Appendix F: Agency Coordination

United States Department of the Interior

**Biological Assessment
Upper Barataria Basin, Louisiana Feasibility Study with
Integrated Environmental Impact Statement**

Figure 9. Mitigation and conservation areas impacted by TSP construction Reaches A & B.

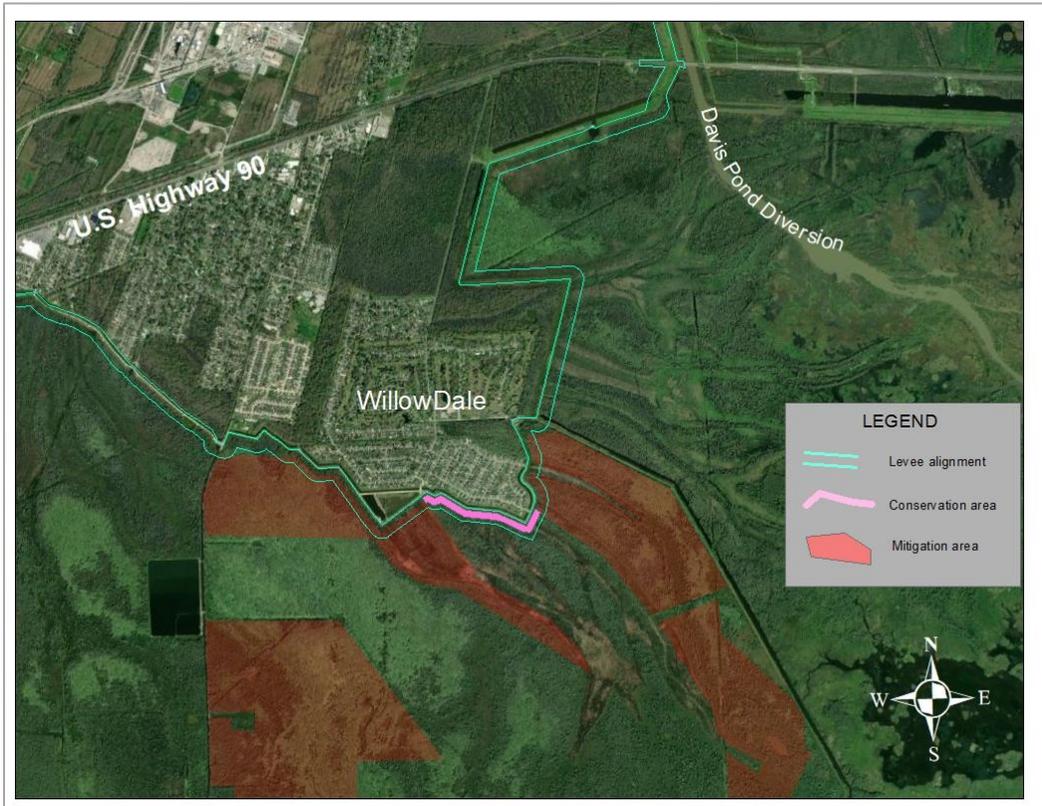
It is assumed that borrow for levee construction will come from existing agricultural areas. If borrow is taken from forested or wetland areas, additional borrow-related impacts would need to be quantified. Construction of the TSP will impact two established mitigation areas and a conservation area on the flood side of the existing St. Charles Parish levee (Figure 9 and Table 4).

Figure 2. Water elevation and ground elevation for CRMS BLH stations 197 and 5116.

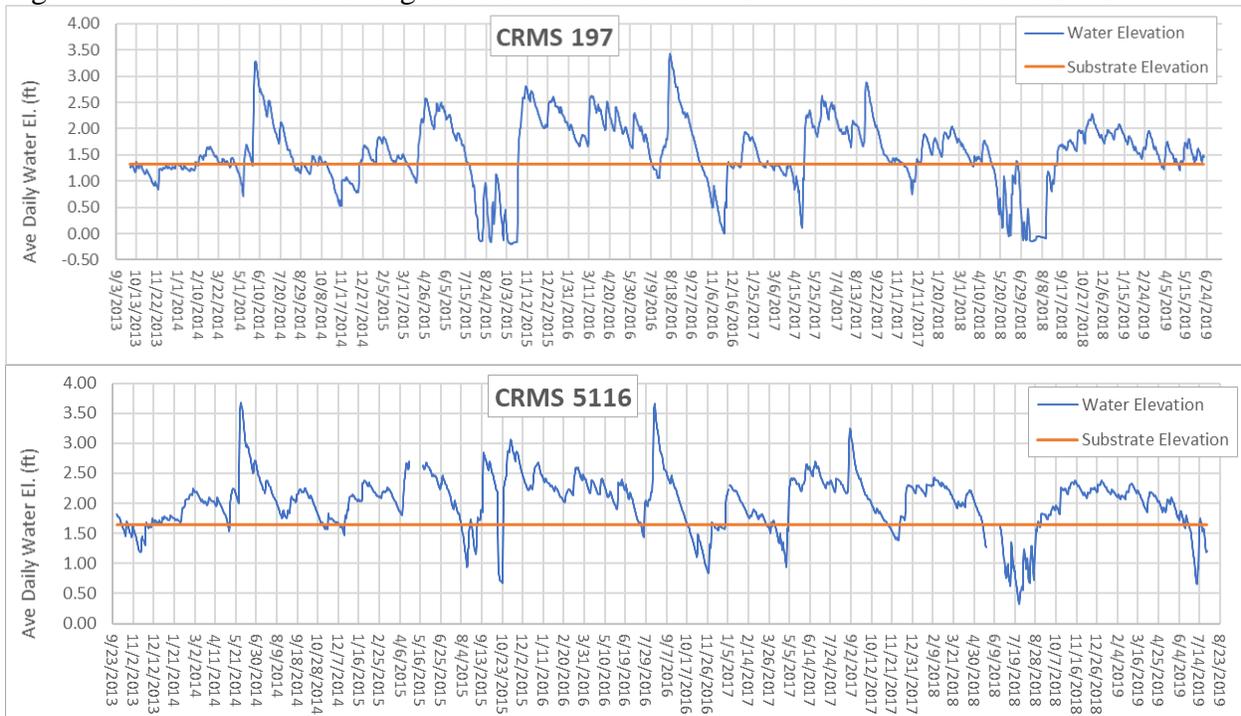
In forested wetlands, CRMS data includes annual or bi-annual diameter at breast height (dbh) measurements of individually tagged/identified trees (Figure 3). At each of the four BLH sites, the total basal area (m^2/ha) has decreased over the 11 year period of record. At two sites, impacts due to Hurricanes Gustav and Ike (2008) resulted in a marked decrease in total basal area. Although there was a quick recovery the following year, the long-term trend in total basal area is downward.

Figure 4. CRMS canopy cover data for BLH stations (2007-2019).

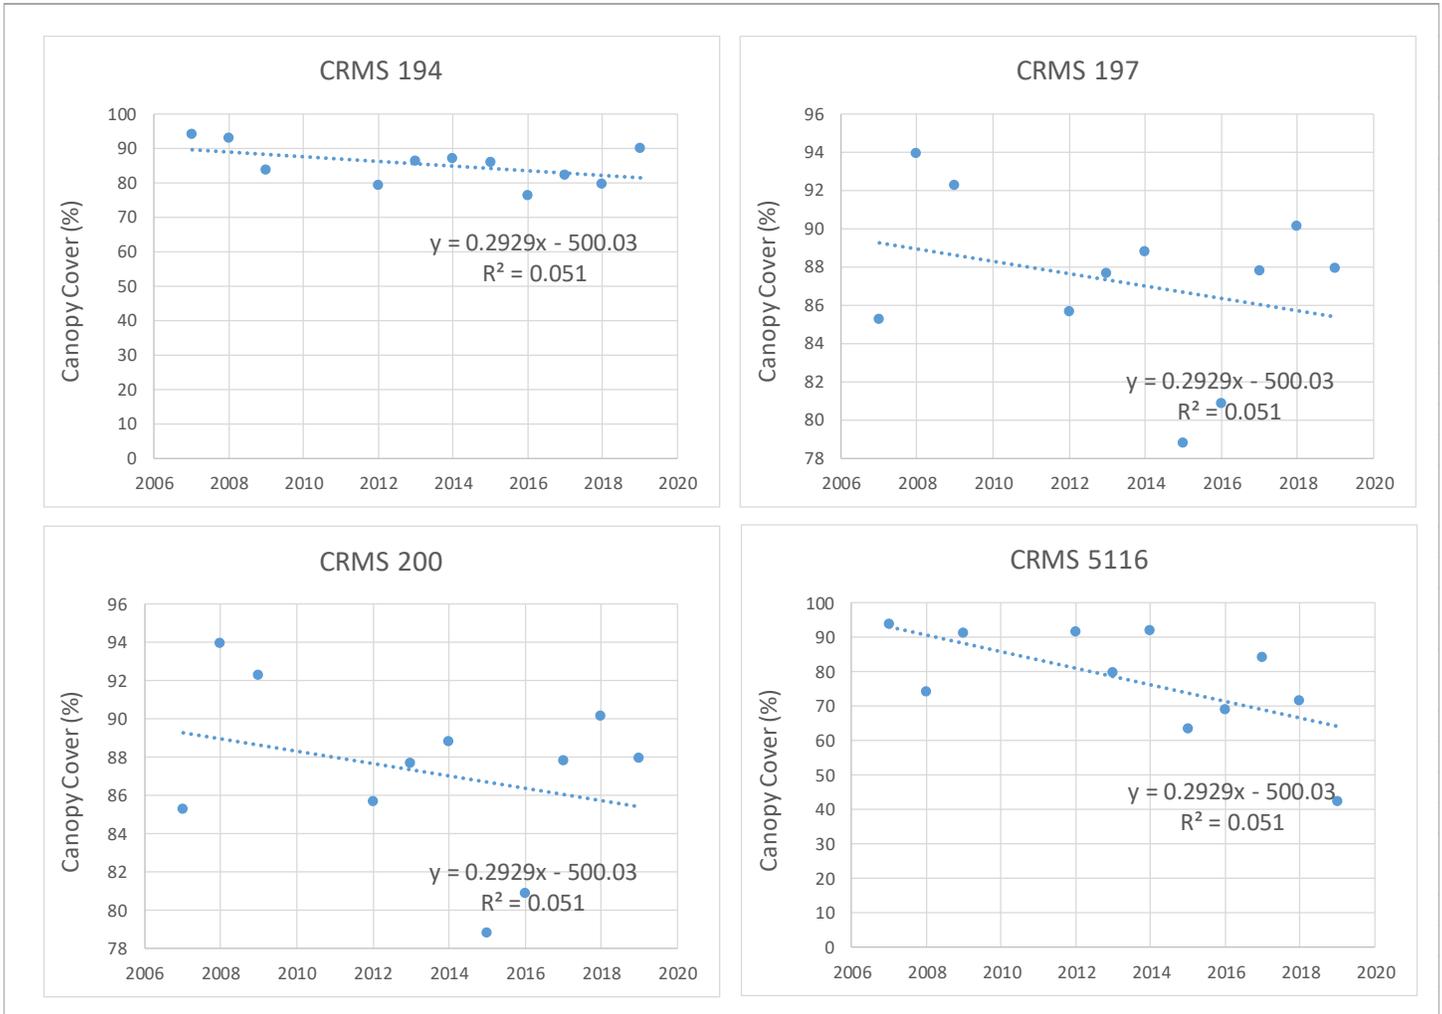
CRMS also measures canopy cover at its forested sites. For the four BLH stations, the canopy cover exhibits a decreasing trend (Figure 4). The decreasing basal area and canopy cover data depict a BLH forest experiencing stress and degradation associated with the prolonged flooding occurring at those sites.

Figure 5. CMRS basal area data by species for swamp stations.

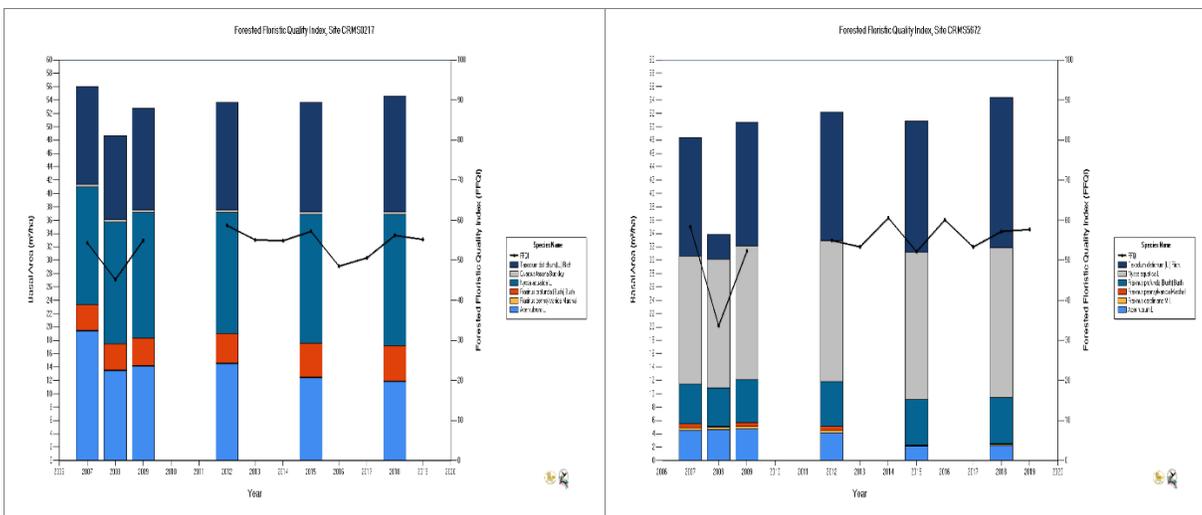
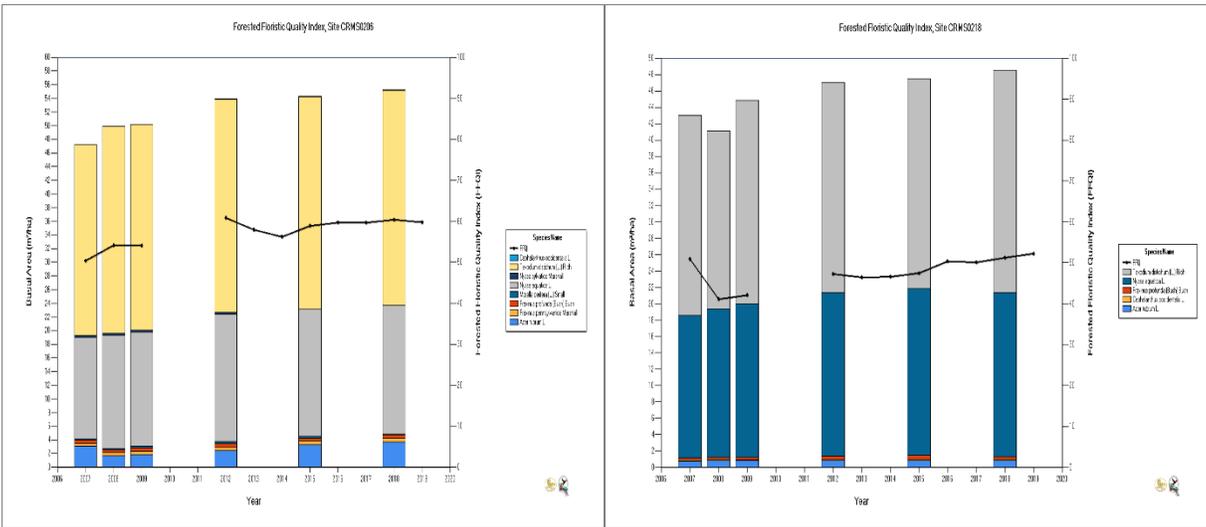
At each of the CRMS swamp sites, the total basal area is trending upward (Figure 5). At several sites, less water tolerant species such as red maple and ash are showing decreases in basal area. Loss of those species may make more resources available for the remaining trees resulting in somewhat greater growth rates due to reduced competition. However, because of the prolonged flooding and lack of regeneration, when the established cypress and tupelo die, the forest will gradually thin out and convert to marsh or open water. Canopy cover data also exhibits an increasing trend in swamp canopy cover (Figure 6). These data suggest that the remaining cypress and tupelo are continuing to grow while other less water tolerant tree species are disappearing.
